# HISTORIC AND DESIGN REVIEW COMMISSION

**HDRC CASE NO:** 2023-001  
**ADDRESS:** 401 KING WILLIAM  
**LEGAL DESCRIPTION:** NCB 745 BLK LOT SE IRR 279.44 FT OF 1, 2 & 3  
**ZONING:** R-4 S, H, RIO-4  
**CITY COUNCIL DIST.:** 1  
**DISTRICT:** King William Historic District  
**APPLICANT:** Samuel White/Michael G. Imber, Architects  
**OWNER:** Jane Lewis/NATIONAL TRUST FOR HISTORIC PRESERVATION IN THE US  
**TYPE OF WORK:** Construction of a visitors' center  
**APPLICATION RECEIVED:** December 23, 2022  
**60-DAY REVIEW:** Not applicable due to City Council Emergency Orders  
**CASE MANAGER:** Edward Hall

The applicant is requesting conceptual approval to construct an accessory structure to function as a visitors' center on the property at 401 King William, commonly known as Villa Finale.

**Historic and Design Review Commission**  
***Design Review Committee Report***

## PROPOSED SOUTH ELEVATION

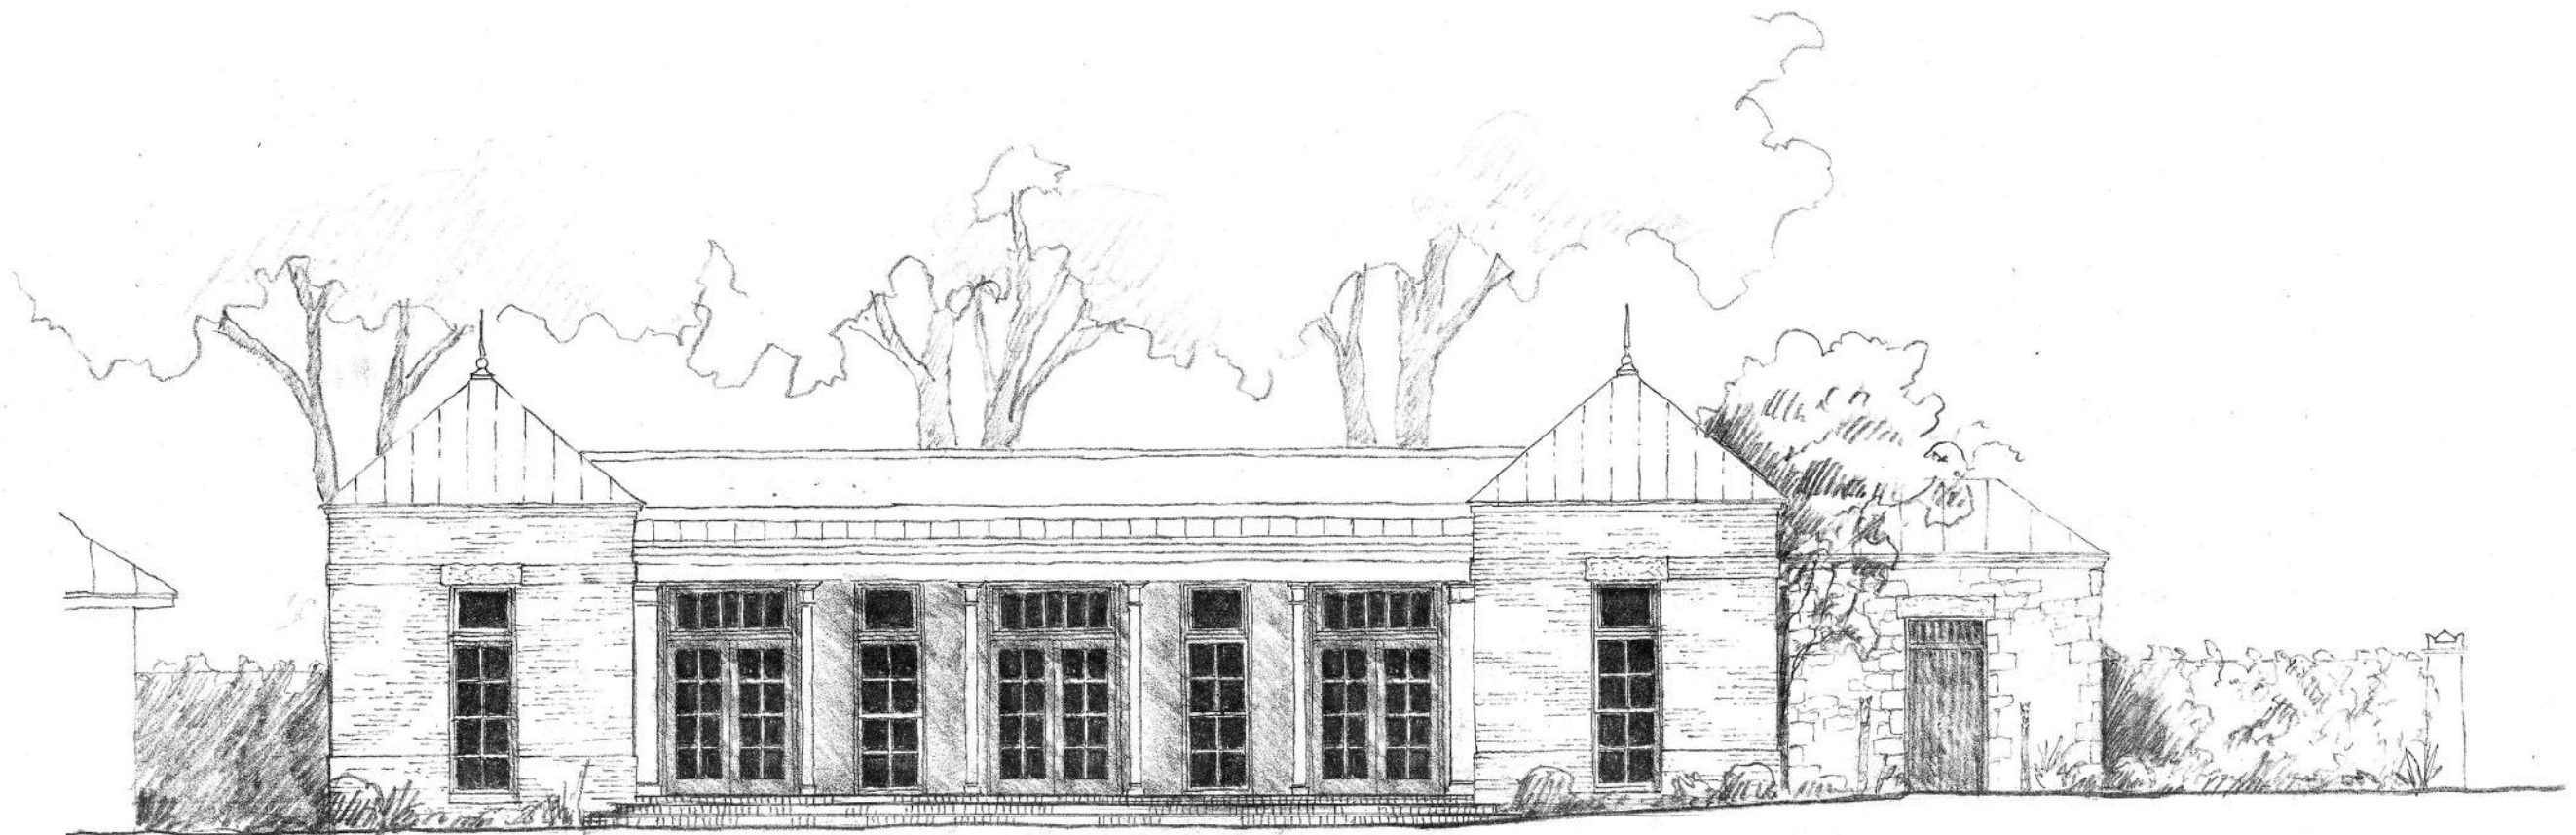
JF: General comments on south elevation. Provide additional information.

STUCCO

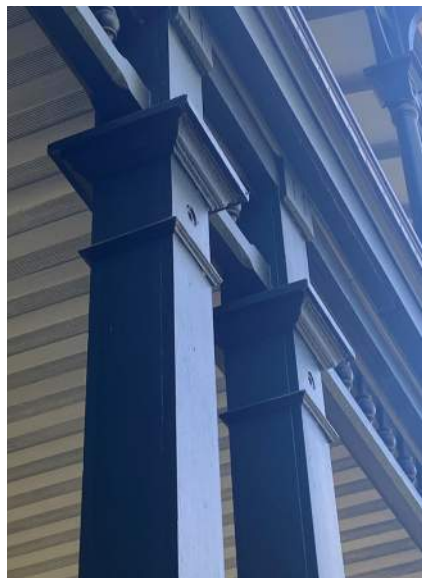
to be appropriate and consistent with the Guidelines. Staff finds that the proposed stucco should feature a texture and profile that is consistent with that found historically on site.

- i. That the proposed stucco be detailed and feature a texture that is consistent with stucco found historically on site, as noted in finding h.
- ii. That all windows be consistent with the adopted policy guide for windows.
- iii. That the applicant submit a detailed landscaping plan for review and approval when returning to the Commission for final approval.
- iv. ARCHAEOLOGY – The project shall comply with all federal, state, and local laws, rules, and regulations regarding archaeology, as applicable.
